Engineering Bulletin #114 Wiring Change for Magnetek DSD412 SCR Drives on Tricon Controllers

Wiring Change for Magnetek DSD 412 SCR Drives

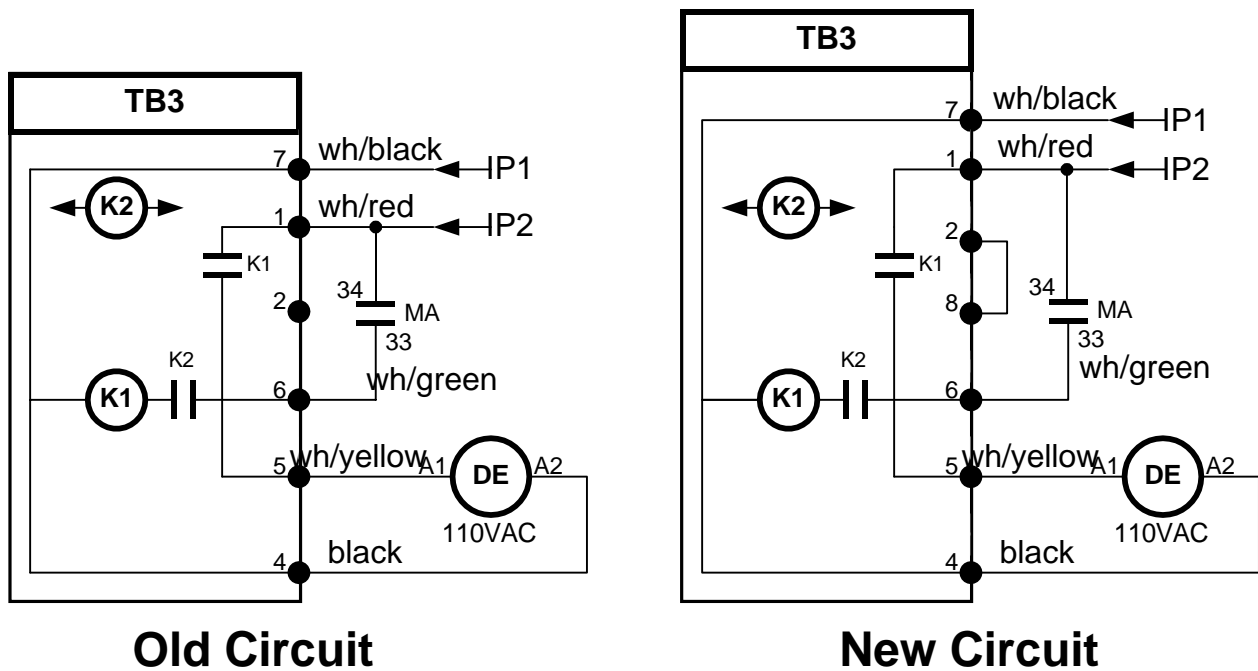
First, remove power from the controller. Looking at the front of the drive you will see wiring coming to the left side of the drive near the top. This wiring is adjacent to the drive display. This connector to the drive is TB3. Remove it by pulling it straight out. Install a jumper from TB3-2 to TB3-8. **Please note that the bottom terminal on this connector is pin 1.** After installing the jumper, plug the connector back into the drive. Refer to the diagrams below:

After installing the jumper on TB3-2 to TB3-8, refer to the “Relays Section” of the prints. Locate the “Drive Fault” contact on this page.

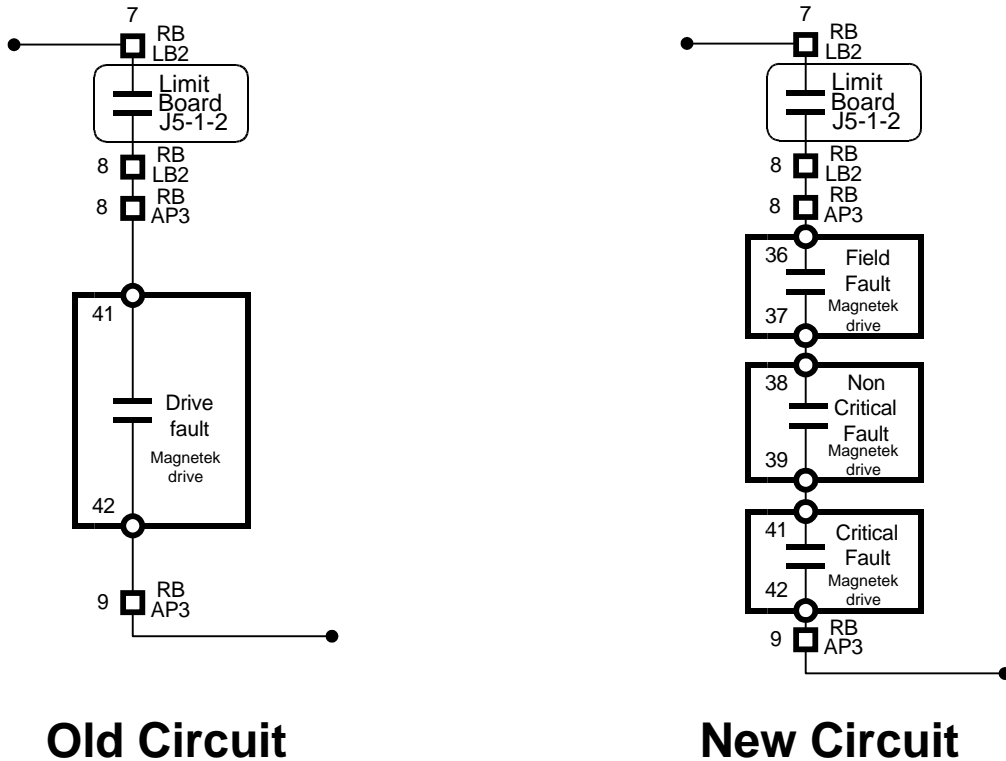
Remove the bottom cover of the front panel on the drive. This will expose terminal block TB1. On the top row of the connector on the right side, locate terminal 41. Remove the wire that is presently connected there and place it in terminal 36. Install a wire from terminal 37 to terminal 38. Install a wire from terminal 39 to terminal 41. Tighten all wiring securely. Refer to the diagram below for the proper connections.
